CAMPUS WIDE, REPLACEMENT/REHAB SAN SEWER SYSTEM CAT 5.5
South Dakota State University
Brookings, South Dakota
OSE# R0323--03X/ARPA
2024

ADDENDUM NO. 1

November 6, 2024

SHEET NO.
H110

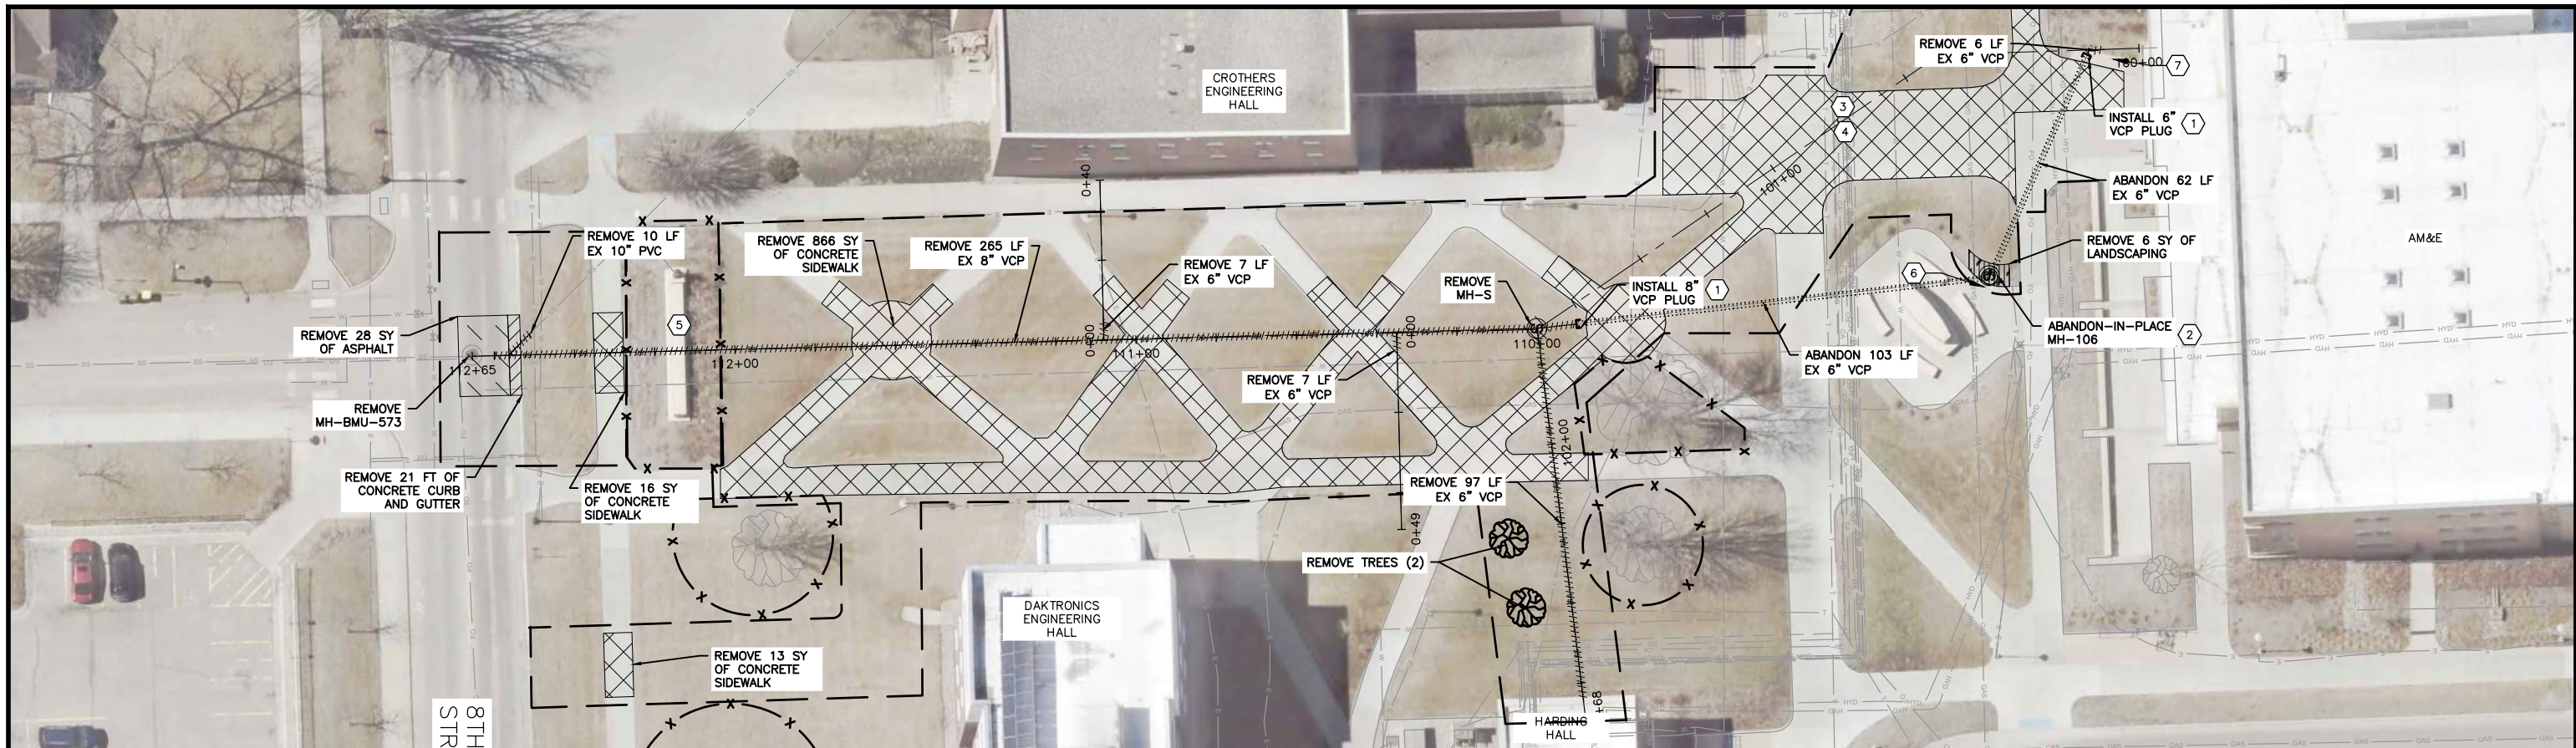
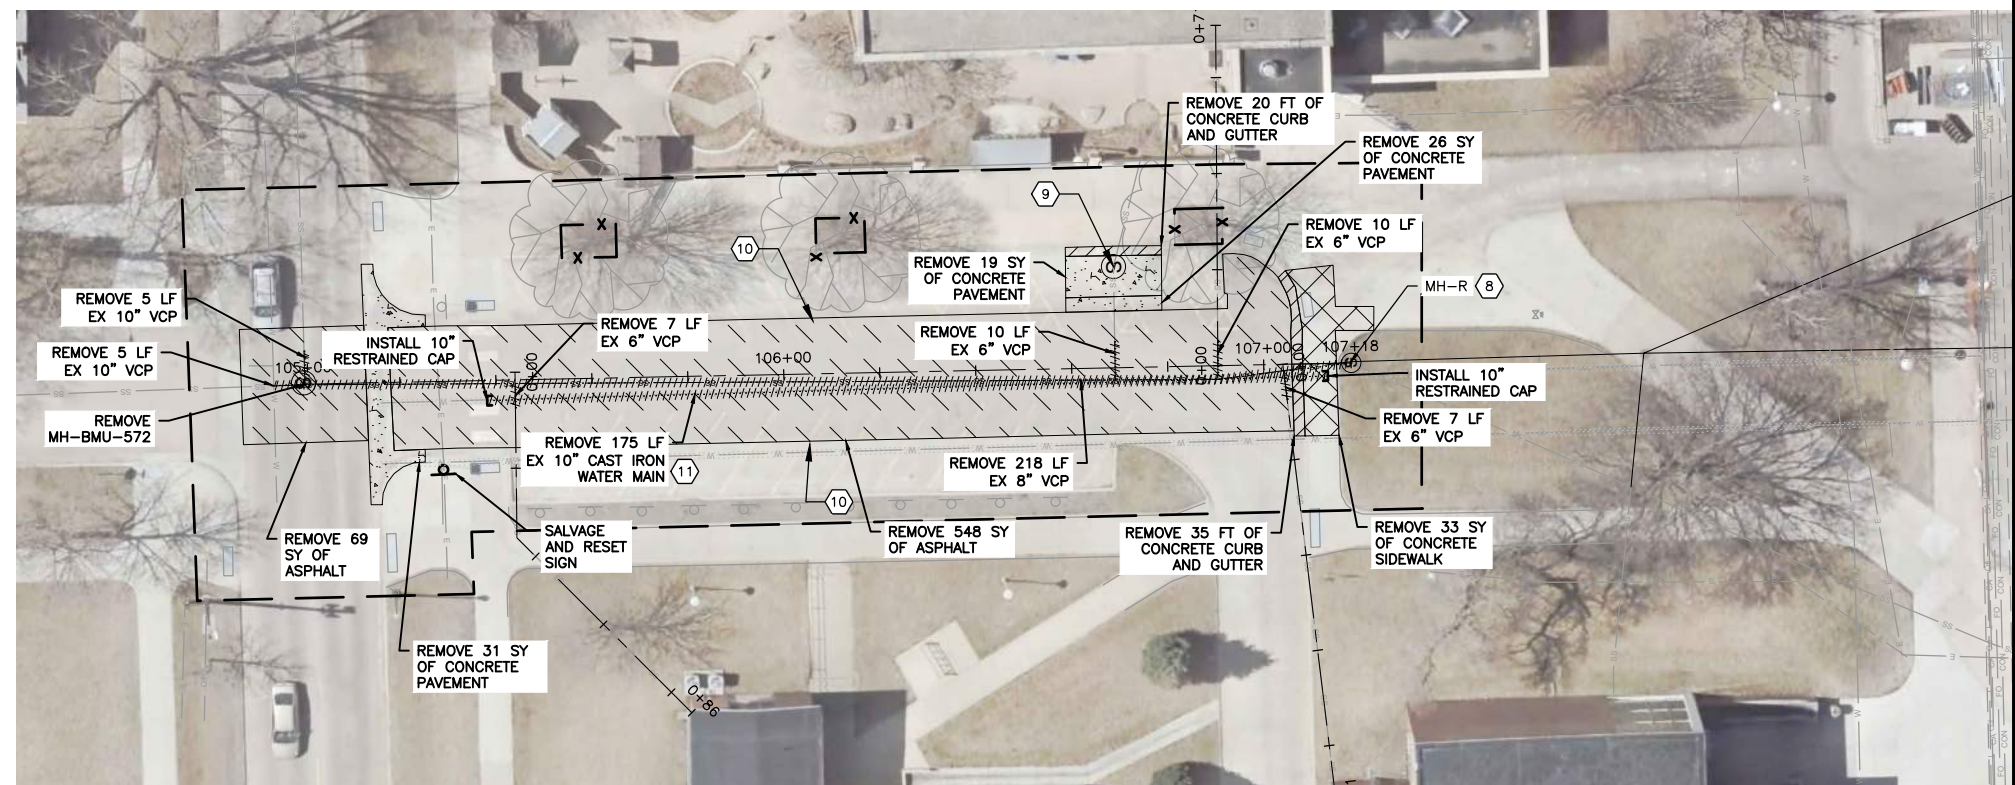
Adjusted viewport of Detail #2.

SHEET NO.
H111

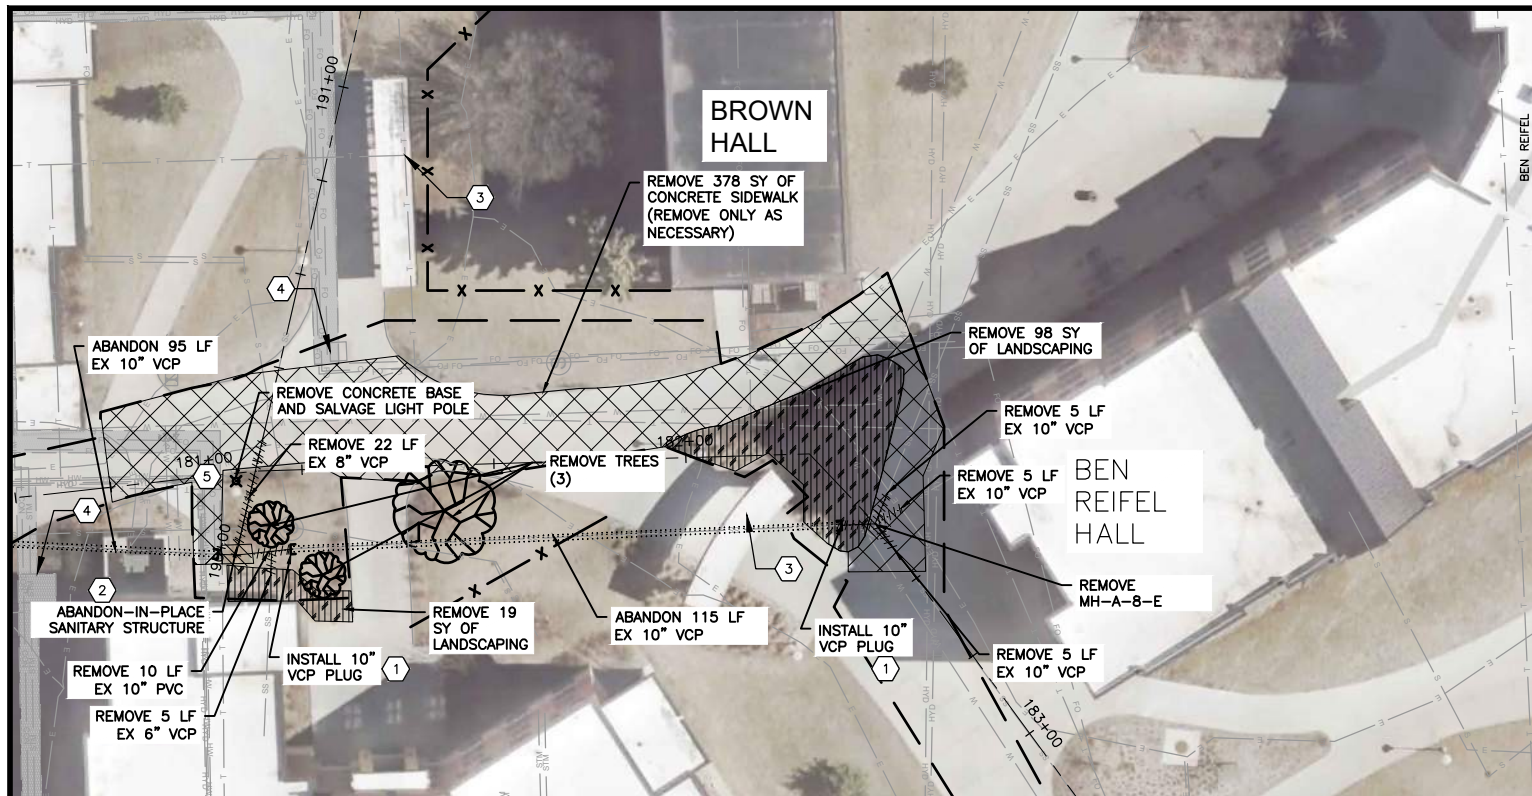
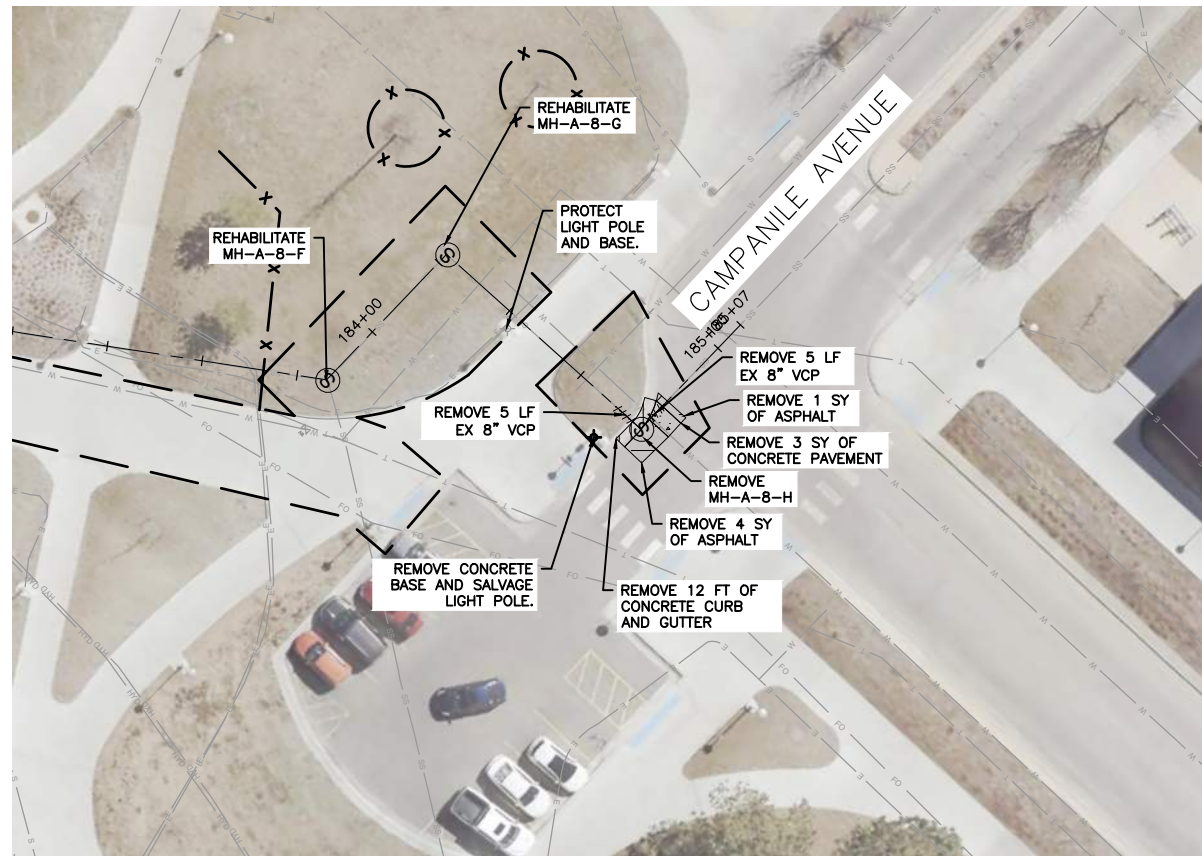
Modified removal call outs and keynotes.

SHEET NO.
H112

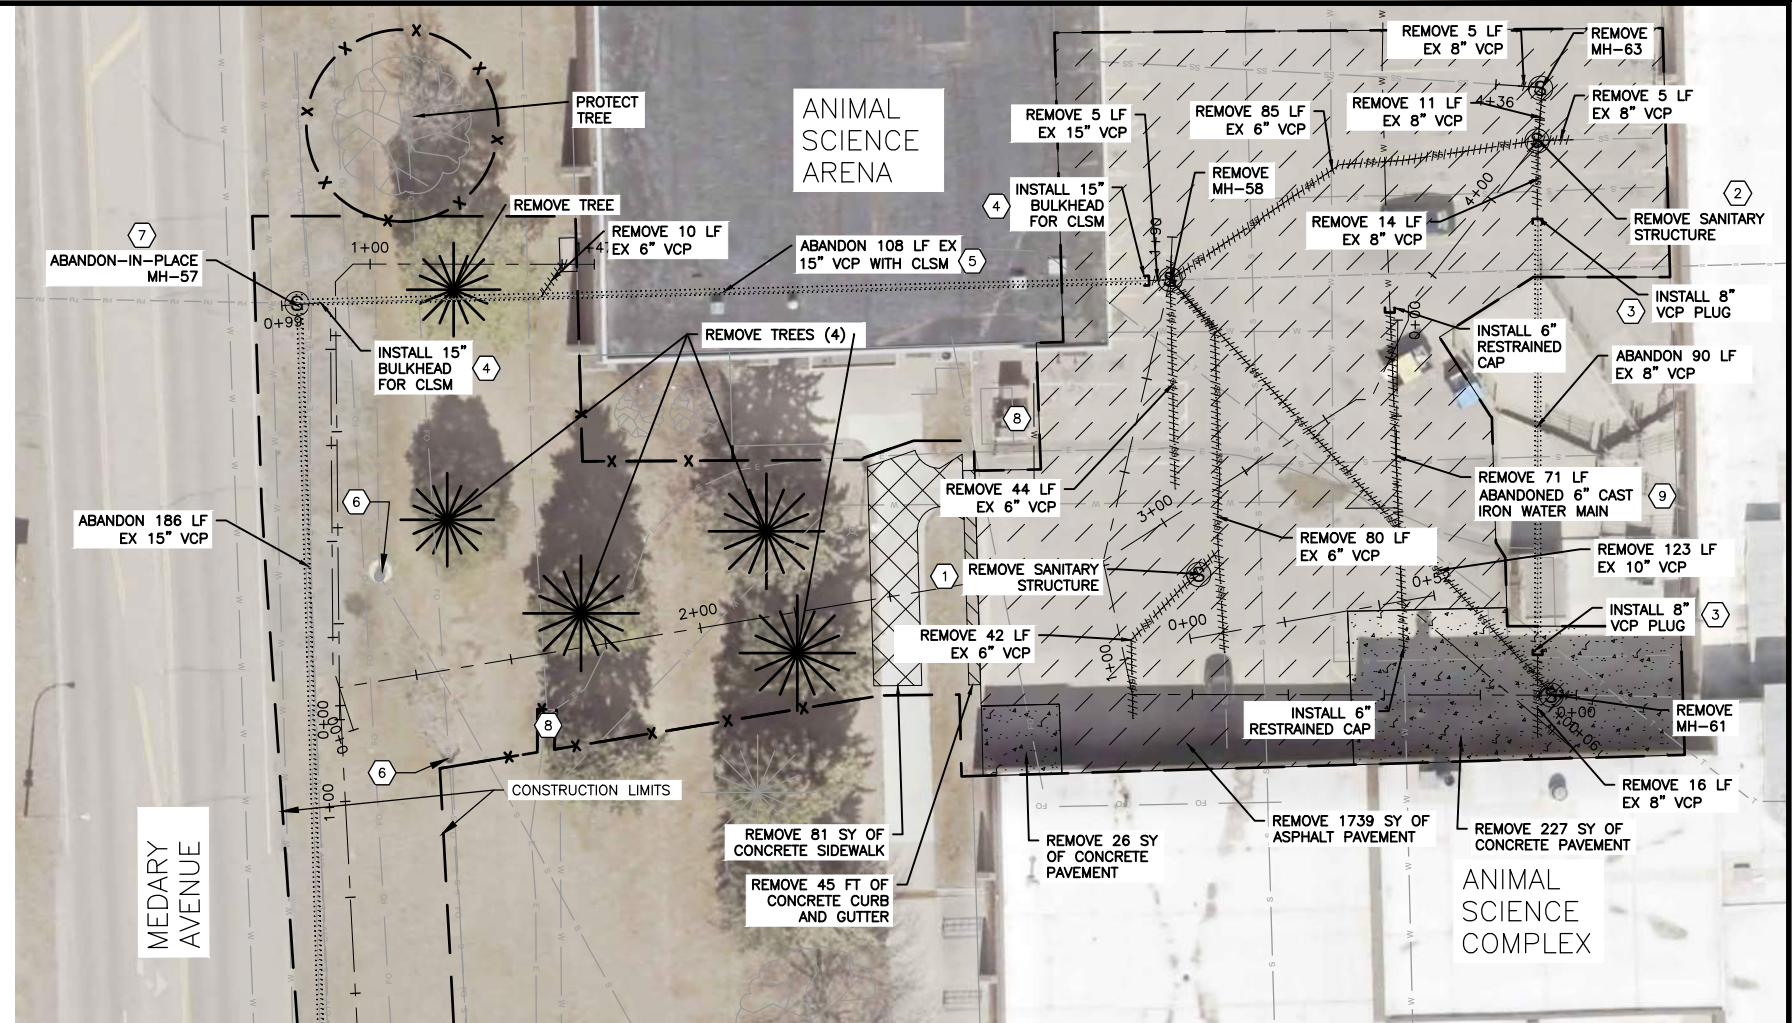
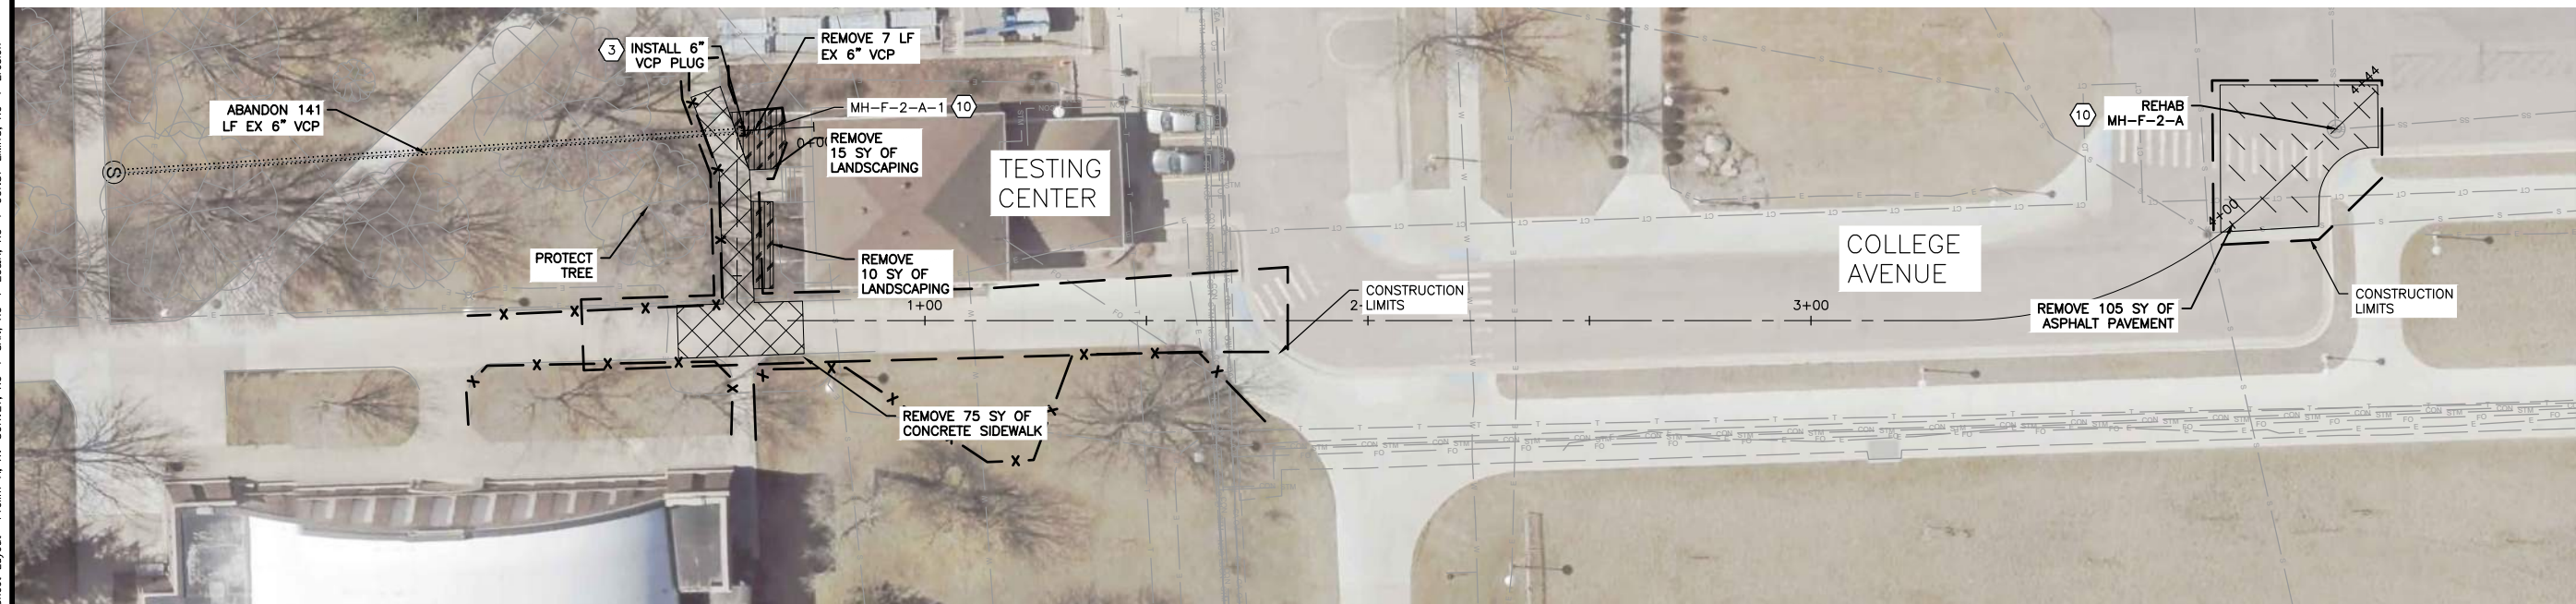
Modified removal call outs and keynotes. Added Detail #3, EXISTING STRUCTURE LID SECTION VIEW and Detail #4, EXISTING STRUCTURE LID PLAN VIEW.
